***MODIFICATION REQUEST:  
Project Application – Blocks 1 and 4N***

***Central Park, Chippendale  
(MP 08\_0253 MOD 6)***

Secretary's  
Environmental Assessment Report  
Section 75W of the  
*Environmental Planning and Assessment Act 1979*

**Figure 3:** Excerpt of proposed architectural plan of Basement Level of Blocks 1 and 4N illustrating the location of the CTP.

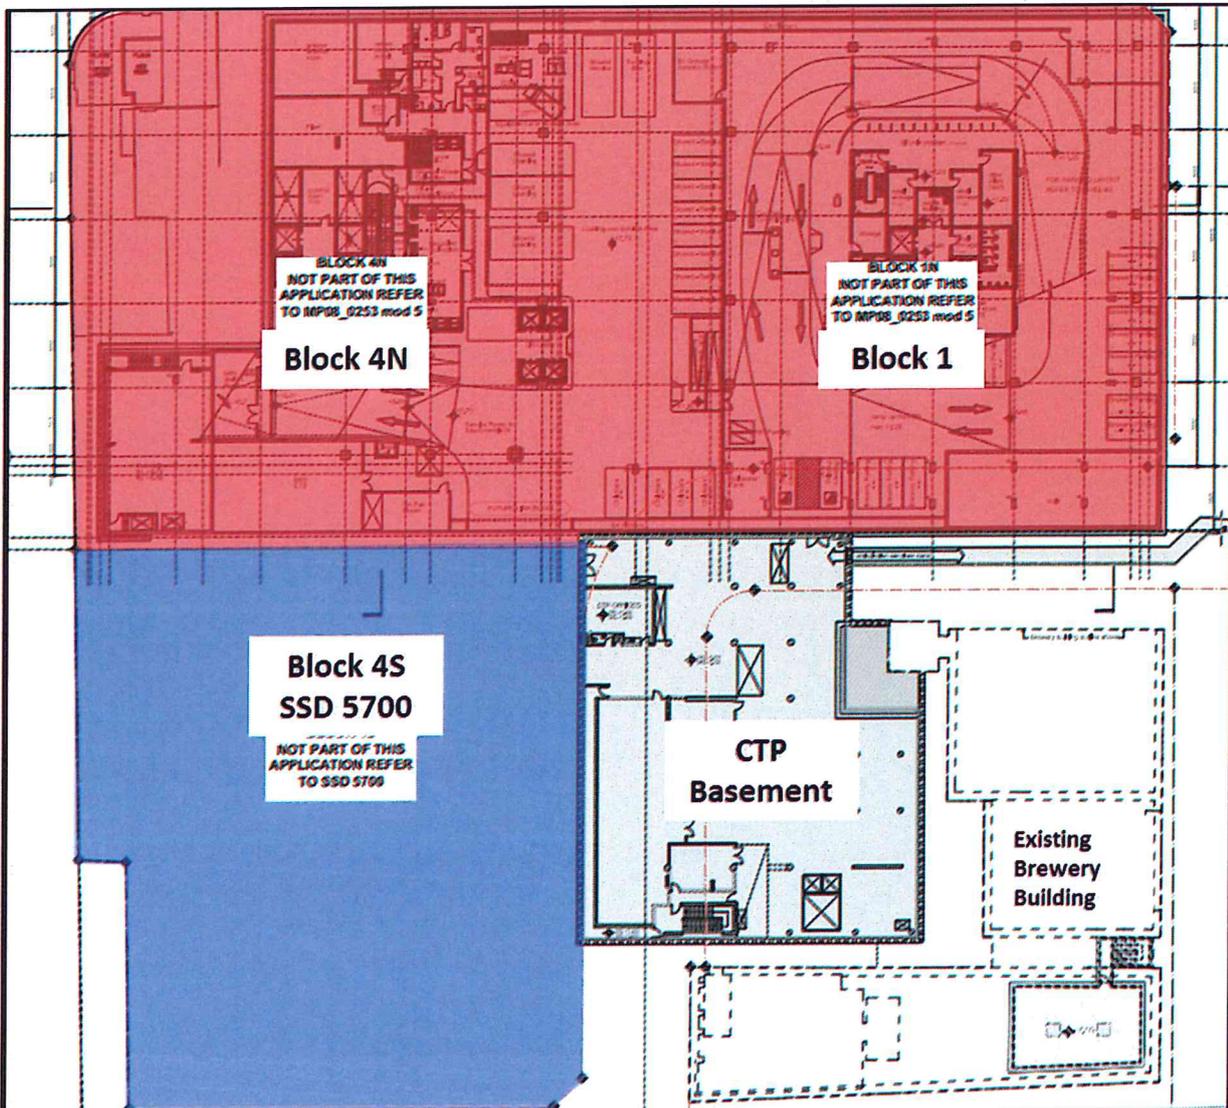
- reinstate the previously approved CTP space located in the basement of Block 1 and 4N under the brewery yard (**Figure 3**);
- install a second 1.1 MW tri-generation gas engine and associated infrastructure within the CTP space; and
- amend the following conditions of the approval:
  - conditions A13 and B42 to ensure the Construction Certificate (CC) for Stage 1A includes the installation of the second tri-generation gas engine;
  - conditions B44 and F8 to include reference to two tri-generation gas engines; and
  - Condition E21(a) to allow flexibility in the emission reduction system.

Notwithstanding, the CTP under the brewery yard was omitted from the basement plans which were approved as part of MOD 4. The proponent therefore seeks to amend the basement plans to reinstate the CTP under the brewery yard.

The Department notes that the exclusion of the CTP in MOD 4 appears to have been in error as a result of the separation of Block 4S from Blocks 1 and 4. The approved CTP is an important component of the Central Park development, contributing to its Green star rating and the ability to achieve a high level of environmental sustainability. Although it was excluded from the plans, the proponent remains committed to delivering the CTP underneath the existing brewery yard. The Department therefore supports the proposed amendment to reinstate the previously approved CTP into the basement plans for Blocks 1 and 4.
